NEWTOWN TO CITY
TRANSITIONAL CYCLEWAY
90% DETAILED DESIGN ROAD SAFETY AUDIT
PREPARED FOR WELLINGTON CITY COUNCIL
March 2022

Newtown to City Transitional Cycleway 90% Detailed Design Road Safety Audit

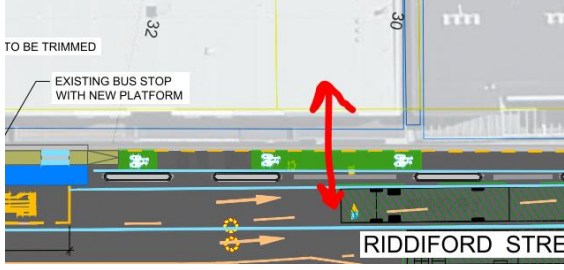
In reviewing the 90% Detailed design the SAT acknowledge that there has been an addition of green surfacing at conflict points, however, there remain locations where additional surface markings are required.

1. 32 Riddiford Street - off street parking accessway
2. Girton Tce – green dashed lines over intersection
3. Bus / cycle lane Riddiford Street right turn into Adelaide Road – dashed green line through on bus lane path to highlight special vehicle lane.

Frequency Crashes are likely to be occasional	Severity Death or serious injury is likely	Rating The safety concern is moderate
Designer response	<p>32 Riddiford Street access has green markings on drawings. No change proposed. Should be noted that Council have requested rationalisation of the green surfacing to high-risk locations only. This will be reflected in the 100% designs.</p> 	<p>Cycle lane does not start till after Girton Terrace, as the area where cyclists will be travelling is a bus lane rather than a cycle lane there are issues with placing cycle</p>

warning markings in a bus lane. Sharrow symbols could be marked at high risk locations. Do not think Girton Terrace meets this criteria – no change proposed.
	Do not see safety benefit from marking green dashed continuity line through intersection, proposed signage (to be included with 100% design) and other markings sufficiently convey allowed movements from the left lane on Riddiford Street. No change proposed.
Safety Engineer comment	Agree with Designer.
Client decision	Request from Cycle advocacy group for additional green dashed continuity line through intersection.
Action taken	Update plans to reflect the green dashed continuity lines through John Street, Adelaide, Riddiford Street.

Figure 2-1: Riddiford Street southbound bus stop

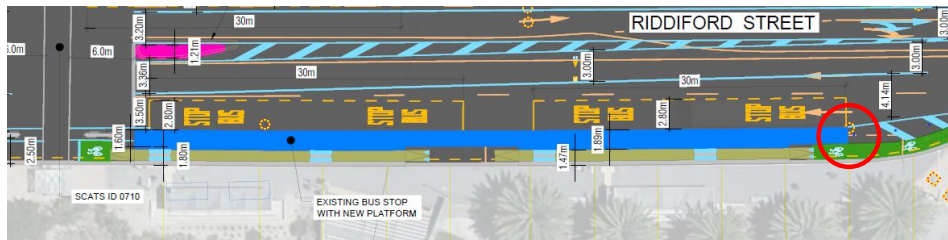
In reviewing the design, the SAT noted that the platforms are formed with square end raised ends (circled below). This will result in a vehicle / motorcyclist / cyclist snag point should an errant user impact with the end of the platform. For vehicles, the damage would be predominantly vehicle damage only, however for a motorcyclist and cyclist the injuries could be serious, with a resultant loss of control into the adjacent traffic lane and risk of impact from other traffic.

It is noted that the southbound lane leading into the bus stop is a general lane north of the hospital road intersection but is multiple bus stops following. This could cause late lane changes should a bus stop in the bus stop. It is acknowledged that as a general operation, buses will stop in traffic lanes to onboard / disembark passengers. Predominantly this occurs in the marked bus lane and should have little impact on the general user. In and around the hospital the stopping in the general traffic lane will have a greater impact.

Frequency Crashes are likely to be occasional	Severity Death or serious injury is likely	Rating The safety concern is moderate
Designer response	Markings guide vehicles to avoid end of platform – no change proposed.

Acknowledge risk identified by SAT, however, limited opportunity to mitigate in the limited space in advance of the intersection – no change proposed.
Safety Engineer comment	Agree with Designer.
Client decision	Agree with above
Action taken	No action required

Figure 2-2: Example of additional green markings at bus stops

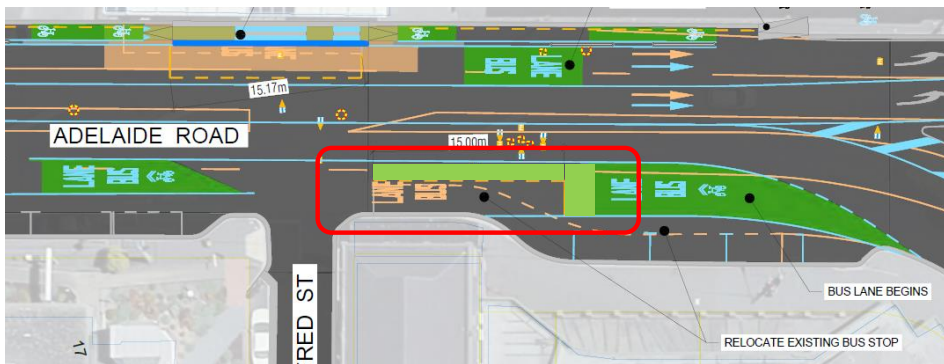
Green markings have been indicated to be installed at the entry / exit to bus stops. Typically, the bus lane is wider than marked bus stop. The SAT are of the opinion that there is opportunity to use a green surface alongside the bus stop to guide cyclists around stationary bus and also highlight to a driver that cycle passing is possible on their right.

The SAT disagree with the designers' comment in their design decision report regarding downhill cycle actions (Pg 10 : Bus Stops). This is copied below. While the decision report does not indicate the meaning of the tick mark, the SAT have assumed that this is the preferred solution for the matter discussed.

Frequency Crashes are likely to be common	Severity Death or serious injury is likely	Rating The safety concern is significant
Designer response	<p>The bus lane width of 3.2 m has been chosen based on best practice guidance¹ to minimise the risk of cyclists attempting to pass buses within the lane. It is acknowledged that the guidance notes: 'For bus stops within narrow bus lanes, the option of indenting bus stops should be considered. Indenting the kerb by 1.0 m at the bus stop will achieve enough width so that people on bikes do not have to join the adjacent traffic lane when passing a stopped bus'. Given the transitional nature of the project, indenting bus stops is not currently being considered. We agree that cyclists will attempt to bypass stopped buses via the adjacent traffic lane. We do not agree that marking green adjacent to the bus stop is the correct approach as that may apply a level of priority and safety that doesn't exist. An earlier concept on Bowen Street included sharrows adjacent to the bus stop as shown below. We recommend this is incorporated into the design.</p>

Safety Engineer comment	<p>Agree in part with Designer. Marking a substandard narrow bus stop bypass lane would be unsafe. Sharrows should not be used in the adjacent lane. It is expected that should cyclists wish to overtake, they will enter the general traffic lane gaps permitting.</p>	
Client decision	<p>No sharrows to be added. Agree with Safety Engineer</p>	
Action taken	<p>No action required</p>

Figure 2-3: Riddiford Street Bus Platform and adjacent cycle lane

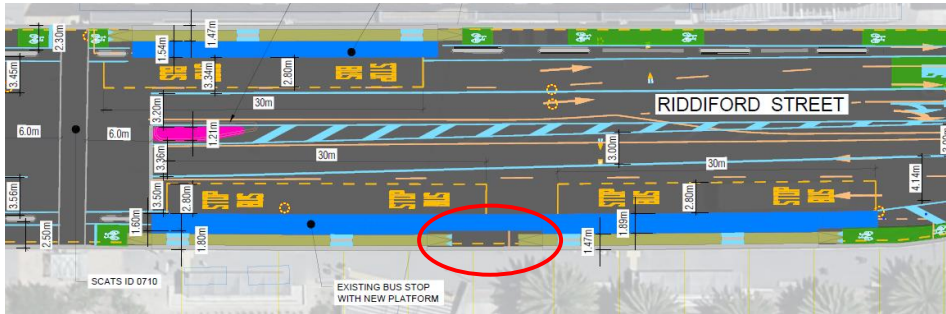
The drawings provided are considered indicative of the design intent and lack clarity of the treatments required for the full consideration of the bus stop use.

The SAT comment that the design includes pedestrian style crossings at multiple locations, assuming that these relate to the door positions of buses. The SAT comment that the bus will operate with both front and rear doors, therefore multiple crossing points will be required to accommodate the movement positions, not just front door. The design lacks clarity around the provision of TGS1 for the bus stops and movement positions over the cycle facility. Tactile and lead pavers are required for bus stops.

A feature of the Hospital bus stop is the formation of a ramp down / up midway between the two bus stop facilities (circled in Figure 2-3 above). This will result in a trip / fall hazard, and is considered a significant risk to the elderly, mobility impaired and visually impaired.

1. Install pedestrian crossing features for both the front and rear door positions for the bus patron movement over the cycle facility.
2. Install a red pavement surface at bus stops indicating the conflict zone between bus patrons and cyclists.
3. Develop a Signs & Markings drawing set prior to going to Tender. This drawing set should be reviewed to ensure that all required elements are incorporated into the design.
4. Apply a consistent bus stop treatment to ensure consistency over the greater Wellington cycle network.
5. Eliminate the set-down section between the two bus platforms

Frequency	Severity	Rating
Crashes are likely to be occasional	Death or serious injury is likely	The safety concern is moderate
Designer response	Council have purchased an off the shelf product which includes coloured components to highlight risk areas as shown below. It is acknowledged that conflicts

The 100% designs will include a signs and marking drawing. Signage for cyclists at bus stop conflicts will be provided where passengers will be alighting directly into the cycle path (not relevant for this section).

Risk of ramp down / up midway between the two bus stops noted but disagree that the risk is significant. The likelihood of a crash should be low given most patrons will walk directly from the bus to the footpath – not along the platform. The additional ramp will help slow cycle speeds which supports the SAT's concerns about 'cyclists impacting with the elderly while the elderly were alighting from the bus'. No change to ramp proposed.

Figure 2-5: Riddiford St / Adelaide Road / Johns Street

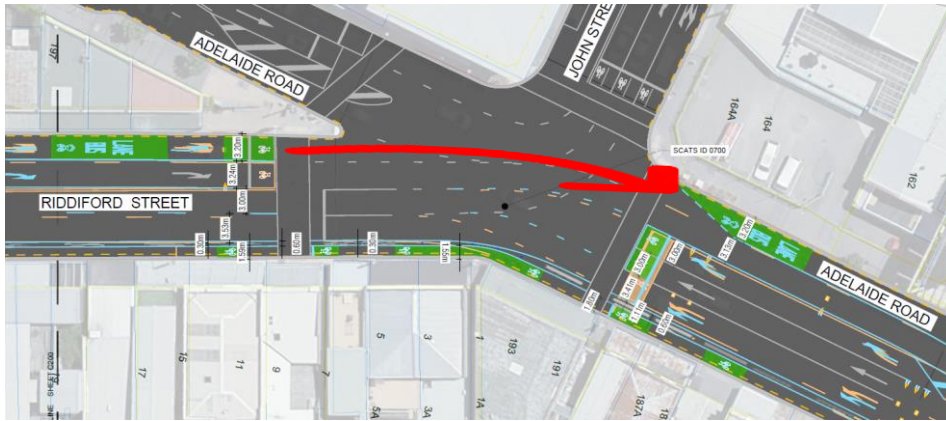
Cyclists northbound on Riddiford Street and continuing onward along Adelaide Road to the city will do so from the left-hand bus lane / cycle lane. The design incorporates an advance stop box to assist the cyclist as detailed in Figure 2-5 below.

The bus / cycle lane is marked in accordance with the two user classes; however, the lane markings (left turn arrow) would prohibit a through movement of both a bus and a cyclist unless an exemption is enabled. This has not been detailed.

Frequency Crashes are likely to be common	Severity Death or serious injury is likely	Rating The safety concern is significant
Designer response	As noted in response to 2.1.1 proposed signage (to be included with 100% design) and other markings sufficiently convey allowed movements from the left lane on Riddiford Street. No change proposed.	
Safety Engineer comment	Agree with SAT – signal information should be provided. Key signalised intersections to be reviewed in <i>Safety in Design Workshops</i> .	
Client decision	Road markings updated to include green continuity lines across intersection. Safety in design workshop for signals.	
Action taken	Safety in design workshop for signals. Plans updated.

Figure 2-9: Lane widths on Adelaide Road and width of separators

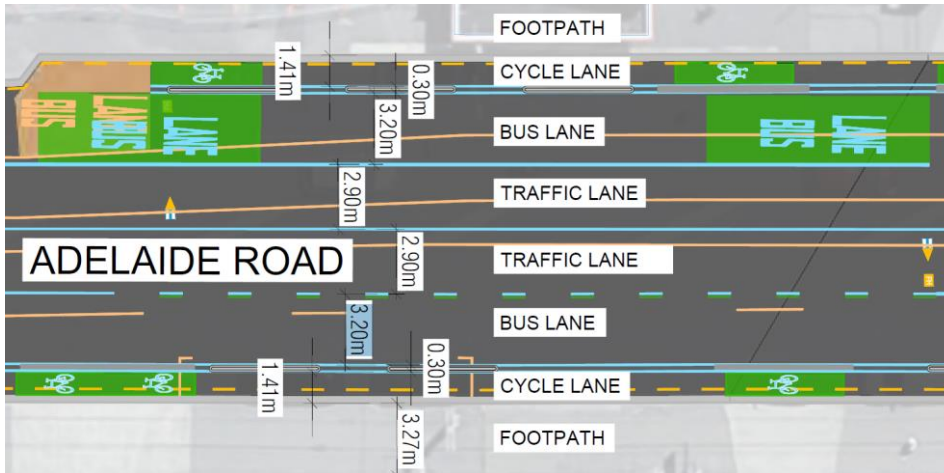
The supplied design drawings indicate that the separator style to be applied along Adelaide Road comprises of a physical buffer, where possible when considering the accesses from adjacent properties.

The road layout dimensions indicate that the physical separator is some 300 mm wide, with a 1.4 metre cycle facility alongside.

The SAT question the viability of a physical separator, especially of a temporary design for this width. It is acknowledged that some "stick-on" type separators closely match this width but would generally eliminate the capacity to install the detailed linework. The preferred separator should be of a size that deters people from driving over them.

1. Detail the specific separator type, and characteristics to ensure that sufficient deterrence is provided alongside the facility.

Frequency Crashes are likely to be occasional	Severity Death or serious injury is likely	Rating The safety concern is moderate
Designer response	Not a concern has physical separators are proposed.	
Safety Engineer comment	It is expected that the physical separators selected are fit for purpose and will deter vehicles driving over them.	
	Performance will be monitored and modified if necessary.	
Client decision	Agree with above	
Action taken	No action required

Figure 2-10: Bus stop south of Broomhedge Street

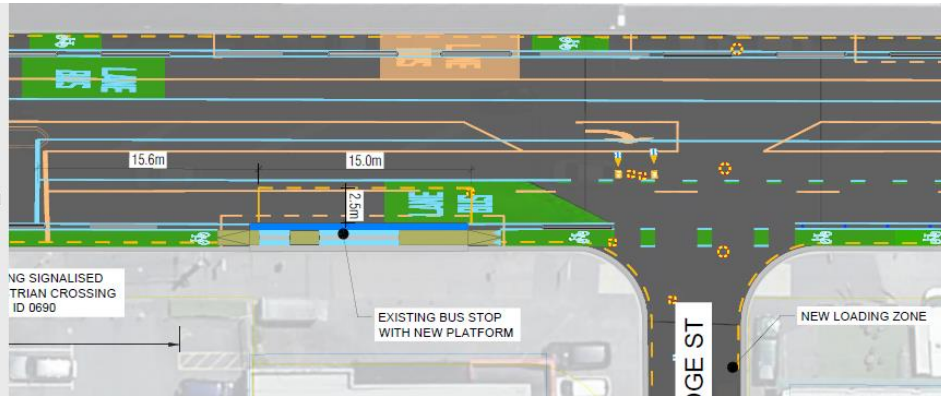
landing space provided is very narrow. No dimensions have been provided on the width of the bus platform, however when compared to the adjacent facility dimensions on the drawing set, it is assumed that the landing space is approximately 500 – 600 mm in width.

The narrow landing space would result in a passenger stepping from the bus directly into the path of a cyclists, with a risk of being clipped by passing cyclists.

1. Undertake a review of the bus platform design for the bus stops located at 101 and 110 Adelaide Road to provide a safe and appropriate landing zone for passengers alighting from the bus.
2. Provide a signs and markings drawing set for the controls required for cycle movement over the pedestrian facilities at bus stops
3. Install red pavement surface to all conflict zones as detailed in Section 2.1.2
4. Implement additional warning treatments into the design to assist Blind Low Vision users at these bus stops

Frequency	Severity	Rating
Crashes are likely to be occasional	Death or serious injury is very likely	The safety concern is significant
Designer response	<p>Council have purchased an off the shelf product which includes coloured components to highlight risk areas as shown below. The intention of the proposed layout shown below is to try and be as consistent as possible with previous treatments around Wellington city including Victoria Street.</p> <p>The 100% designs will include a signs and marking drawing. Signage for cyclists at bus stop conflicts will be provided where passengers will be alighting directly into the cycle path as per below.</p>

Safety Engineer comment	<p>Agree with Designer.</p> <p>The bus platform/cycle product and layout must be monitored and modified if necessary.</p>
Client decision	<p>Agree with above</p>
Action taken	<p>No action required</p>

Figure 2-11: Adelaide Road between Alfred St and Girton Tce – parking with adjacent bus lane

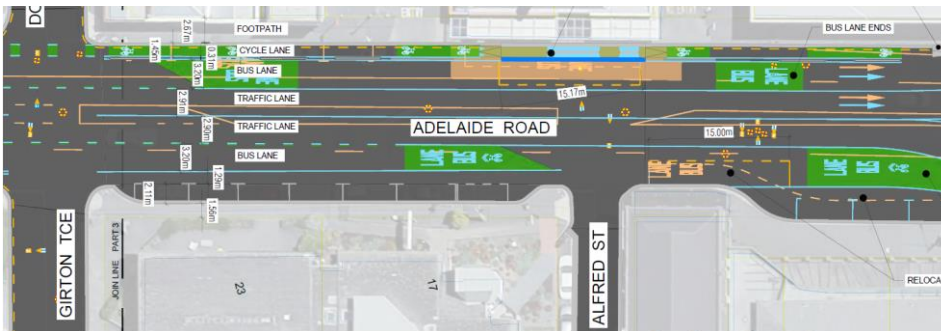
The design proposed has kerbside parking alongside the road shoulder between Alfred Street and Girton Terrace. Alongside this is an unmarked buffer, then the bus lane, as shown in Figure 2-11 below.

The supplied design drawings indicate that there are no side road control markings to define the hold point for Girton Tce. A review of previous site photos, and the aerial plans indicate that there is a current Give Way control. The SAT have assumed that the lack of side road control details is a draughting error, and that the current control will remain.

Frequency Crashes are likely to be occasional	Severity Death or serious injury is very likely	Rating The safety concern is significant
Designer response	Agree – drawings should reflect current give-way controls remain. Dashed green markings concern previously identified in section 2.1.1 – refer previous response.	
Safety Engineer comment	Agree with Designer.	
Client decision	Agree with above	
Action taken	No action required

Figure 2-12: Adelaide Road / Rugby Street Intersection

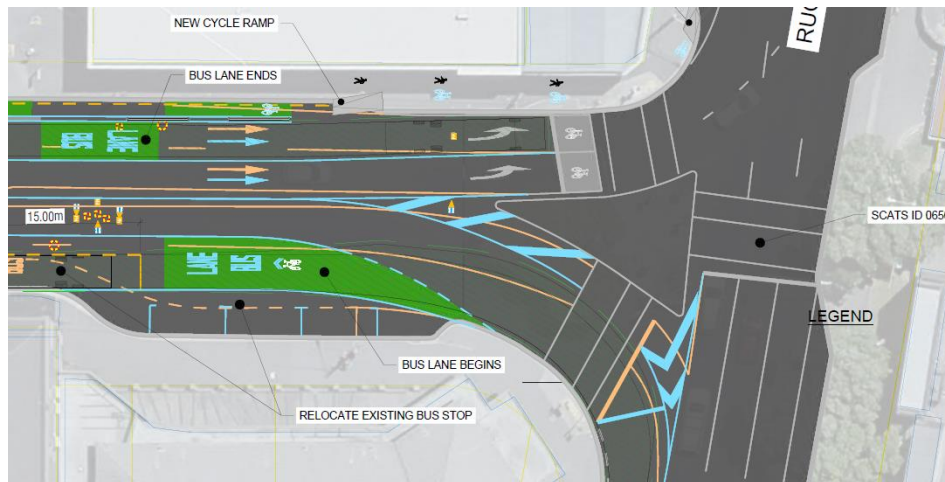
The SAT acknowledge the changes to the lane entry from Rugby Street into Adelaide Road and the inclusion of enlarged advance flush median chevrons, as detailed in Figure 2-12 below.

1. There are no details to the configuration of the central splitter island. The SAT have assumed that there is no change to this arrangement. The SAT comment that the improved cycle facility along this route may result in the general increase in number of cyclists, resulting in a congested wait area.

5. A flush median is shown on the plans at the location of the splitter island. The SAT comment that this could be supported through the use of vertical bollards to reinforce the slow nature of the turn, provide additional stack space and shorten the crossing distance. This further reduces the risk of a driver undertaking a late turn / passing movement using the flush median.

Frequency Crashes are likely to be occasional	Severity Death or serious injury is likely	Rating The safety concern is moderate
Designer response	No change to function central splitter island – no change proposed. Agree that as demand increases the current facilities may become congested this should be considered as part of permanent changes along this corridor. Agree with SAT. Agree with SAT – vertical delineators should be included in the flush median.	
Safety Engineer comment	Agree with SAT and Designer.	
Client decision	Agree with above	
Action taken	Update designs to include additional vertical bollards around median.

Figure 2-13: Cambridge Terrace southern end of cycle lanes.

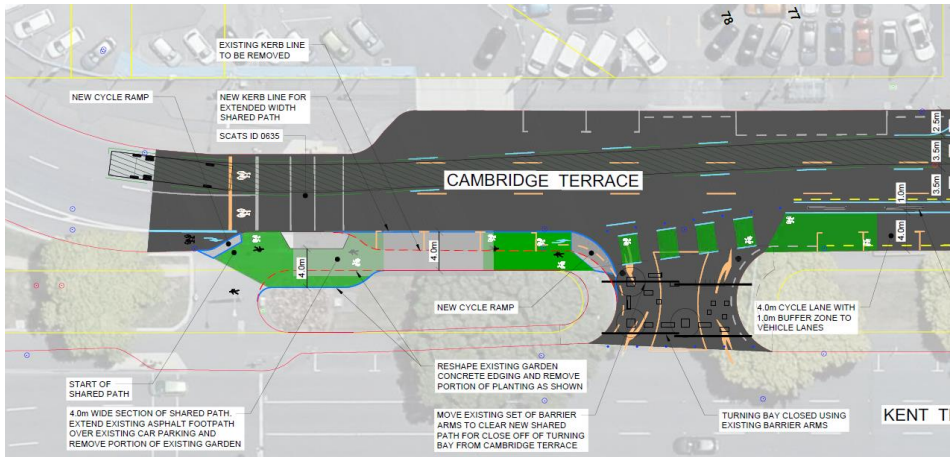
The SAT note the intended start position of the new facilities on Cambridge Terrace, exiting from the Basin Reserve area. Refer to Figure 2-13 below.

The SAT note that for the southbound movement (towards Basin Reserve), there is no guidance into a suitable facility, which could lead to cyclists in conflict with other footpath users either on the central path, or on the footpath on the Kent Terrace side.

The impact of a cyclist with vulnerable users such as the elderly and blind low vision people could result in higher severity injuries. As detailed, the elderly generally has a lower capacity to recover from high trauma injuries, with the resulting injury severity being serious.

Frequency Crashes are likely to be occasional	Severity Death or serious injury is likely	Rating The safety concern is moderate
Designer response	Agree with SAT	
Safety Engineer comment	Agree with SAT. Detail on cycle lane continuity through or around the Basin has not been provided. Although there have been general discussions on way-finding through the Basin, or around the Basin during an event, the absence of acceptable plans and detail continue to pose a moderate to significant risk. These should be included in the final package for overall approval of this cycleway.	
Client decision	Agree with above	
Action taken	No action required

Figure 2-14: Typical U-Turn closure detail

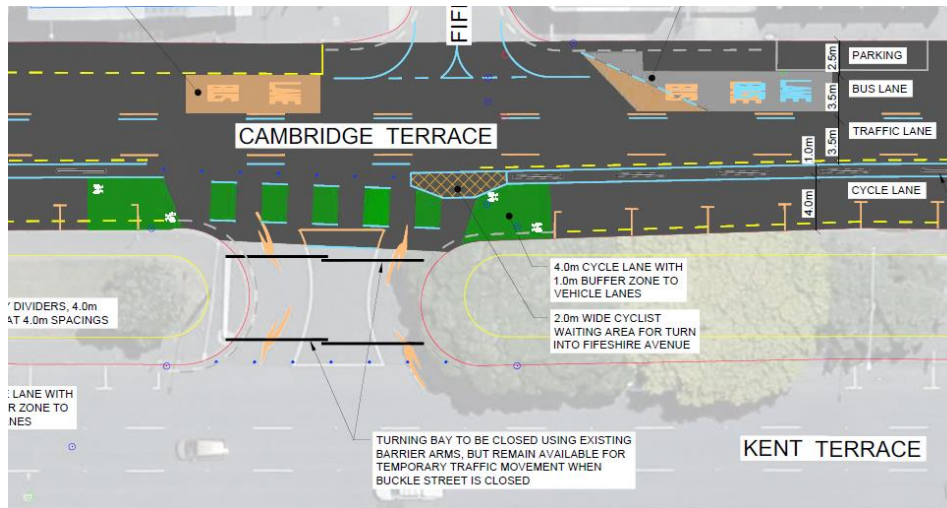
The SAT recognise the design has sought to temporarily close the current U-Turn pockets along Cambridge Tce / Kent Tce. A typical closure detail is shown in Figure 2-14 below.

The use of vertical bollards will initially be effective due to their clean and new visible nature, however over time they will typically degrade and become ineffective. The vehicle movement alongside the bollards will result in wheel splash and covering in road grime. The SAT comment that a high level of maintenance intervention will be required to ensure that the bollards are fit for purpose and remain effective.

1. The design does not detail the effects on the greater network with the closure of the U-Turn pockets in place. The SAT comment that the removal of all U-Turn pockets south of Elizabeth Street may result in adverse turn movements at Vivian Street. The SAT recognise that the closure of the U-Turn pockets will require drivers to traverse around the Basin Reserve or Elizabeth Street to access business / streets on the opposite side of the central median.

1. That ROAD CLOSED / NO ENTRY / NO RIGHT TURN signs are installed on both sides of the central median, highlighting to drivers that the facility is closed.
2. That the bollards on the Kent Tce side are positioned such that safe pedestrian movement via kerb ramps is maintained when crossing over the U-Turn pocket.
3. That a high level of maintenance intervention of the closure bollards is applied on both a reactive and proactive manner.
4. That full retro-reflective material is applied to the barrier arms.
5. A detailed traffic management plan is developed early, that includes all actions, equipment and guidance required to address the change in priority for the U-Turn pocket.

Frequency Crashes are likely to be occasional	Severity Death or serious injury is likely	Rating The safety concern is moderate
Designer response	Agree with SAT – noting that some of these recommendations are already included in the design (e.g. item #2)/ and or currently exist (e.g. item #4).	
Safety Engineer comment	Agree with SAT and Designer.	
Client decision	Agree with above	
Action taken	No action required

Figure 2-15: Cambridge Tce and Fifeshire Ave intersection

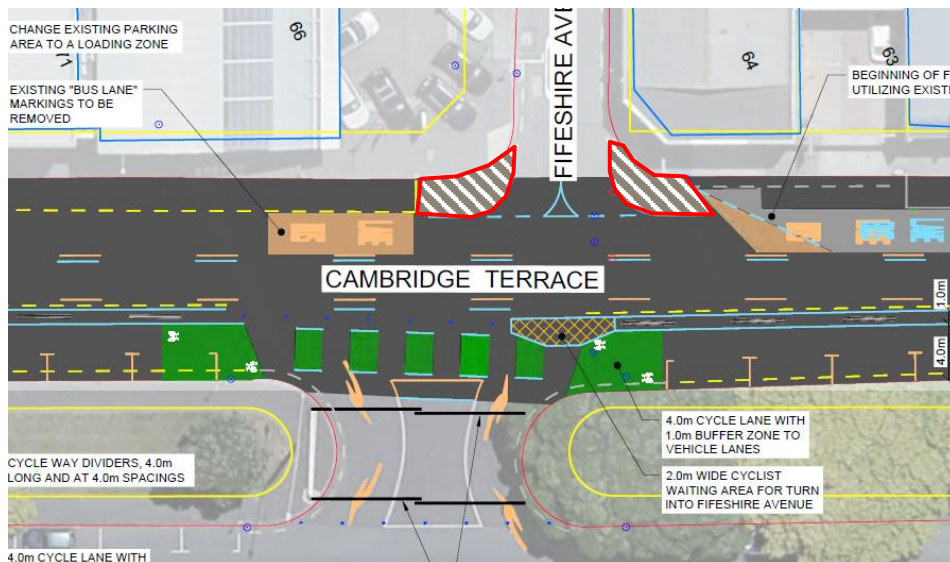
The SAT however do note that the design provides edge lines that commence on the traffic lane side of the loading zone, and turn into Fifeshire Ave, both sides. The current markings could be identified as a parking area. The SAT recommend that shoulder chevrons and no-stopping lines are installed to maintain the intervisibility sight line at the intersection (marked on Figure 2-15 above).

The revised design as presented in the 90% design drawings indicates that the kerb line (southbound, west side) has been adjusted to enable the passing of the bi-directional facility past the hook turn for Fifeshire Ave. The design fails to detail the provisions for pedestrians along the north / south route. The SAT note that with the closure of the U-Turn facilities, the central median route could become more attractive for pedestrian movement north and south as it eliminates the need to cross minor side roads.

1. That shoulder chevrons and no-stopping lines are installed at the Fifeshire Ave intersection to maintain the intervisibility sight lines at the intersection.
2. Change the hatched zone for the turn into / out of Fifeshire Ave to a standard hook turn facility with all markings and signs associated for the expected movements.
3. Confirm that full pedestrian movement is maintained on the west side of the central median.

Frequency Crashes are likely to be common	Severity Death or serious injury is likely	Rating The safety concern is significant
Designer response	Existing no stopping lines remain – no change proposed. This issue has been identified and alternate markings will be developed for 100% designs. Care will need to be taken to not mix the markings up with hook turn markings which are appropriate for a certain function at an intersection. Pedestrian movement will be able to occur, although the closed barrier arms may partially restrict desire lines. No drop-kerbs are currently provided for this pedestrian movement. This has been identified as a potential future enhancement along the corridor.	
Safety Engineer comment	Agree with Designer.	
Client decision	Agree with above	
Action taken	No action required

Figure 2-16: Cambridge Tce / Vivian Street intersection

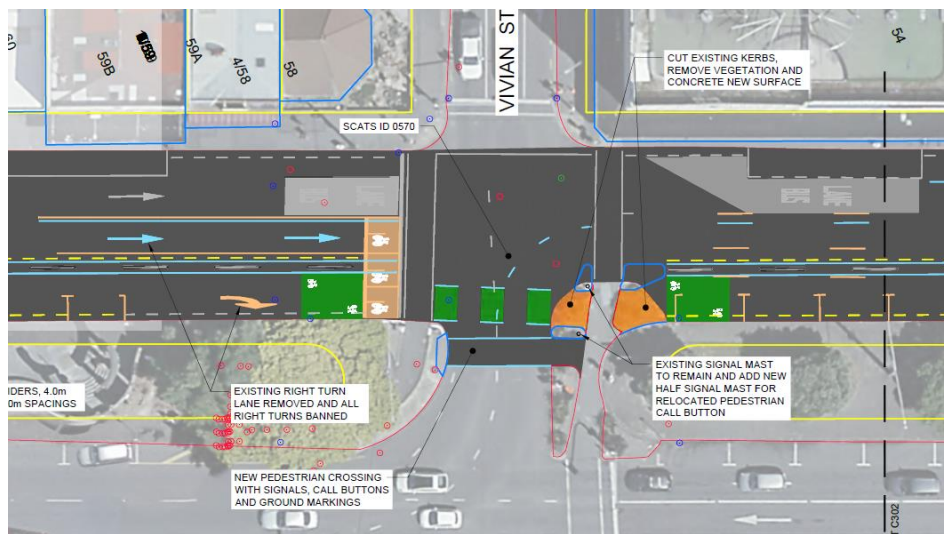
The cycle facility crosses over the pedestrian movement north of the Vivian Street intersection. This crossing does not indicate who has priority – pedestrian or cyclists. The pedestrian will be waiting at the edge of the crossing on the Cambridge Tce side, and depending on user and numbers, would result in pedestrians straying across the cycle path. The SAT recommend that pedestrian crossing bars, with all signs and markings being installed. This crossing requires tactile pavers for the pedestrian movement over the cycle facility.

The SAT consider that given the risk of the pedestrian / cycle conflicts, it is imperative that red pavement markings are installed at the conflict zone.

Frequency Crashes are likely to be common	Severity Death or serious injury is likely	Rating The safety concern is significant
Designer response	Agree with SAT – signal information should be provided.	
Safety Engineer comment	Agree with SAT – items 2-4 – additional information to be included in 100% designs.	
	Agree with SAT and Designer.	
	Key signalised intersections to be reviewed in <i>Safety in Design Workshops</i> .
